# Access Compliance Report

## Public Rights-of-Way

### (Curb Ramps)

Intersection ID: 19505	Main Street: BADENOC_H_CT	Cross Street: GRETNA_GREEN_DR	Location: SW
ADA ID: 6AEEC1681E5A	Ramp Type: Directional1	Initial Pass/Fail: Fail	Overall Compliance: No
Severity Score: 1.25			
Codes/Mitigation Info/Possible Solution		Field Measurements/Component Compliance

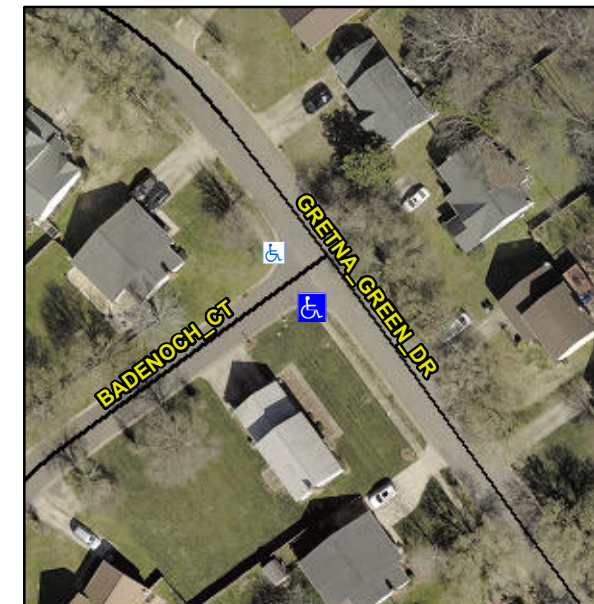
**R304.5.3**

Compliance	Description	Data	Compliance	Description	Data
N/A	Ramp Length (in)	96.0	N/A	Grade Break?	N/A
Yes	Ramp Width (in)	48.0	N/A	Grade Break Slope (%)	0.0
Yes	Ramp Slope (%)	5.7	N/A	Grade Break XSlope (%)	0.0
No	Ramp XSlope (%)	2.1			
N/A	Flare Type LT	N/A	N/A	Flare Type RT	N/A
N/A	Flare Slope LT (%)	N/A	N/A	Flare Slope RT (%)	0.0
N/A	Flare Traversable LT?	N/A	N/A	Flare Traversable RT?	N/A
N/A	Landing Length (in)	0.0	N/A	DWS Provided?	N/A
N/A	Landing Width (in)	0.0	N/A	DWS Contrast?	N/A
N/A	Landing Slope (%)	0.0	N/A	DWS Length (in)	N/A
N/A	Landing X Slope (%)	0.0	N/A	DWS Full Width?	N/A
N/A	Landing Curb? (Y/N)	N/A	N/A	DWS Offset LT (in)	N/A
N/A	Shared Landing?	N/A	N/A	DWS Offset RT (in)	N/A
N/A	Gutter Ponding?	0.0	N/A	Gutter Slope (%)	N/A
N/A	Gutter Lip Ht (in)	0.0	N/A	Gutter X Slope (%)	N/A
N/A	Painted X Walk1?	No		Road Slope (%)	0.4
	X Walk 1 Direction	To NW		Road X Slope (%)	3.7
	X Walk 1 Width (in)	N/A		Clear Space?	N/A

**Remove & Replace Entire Ramp.**
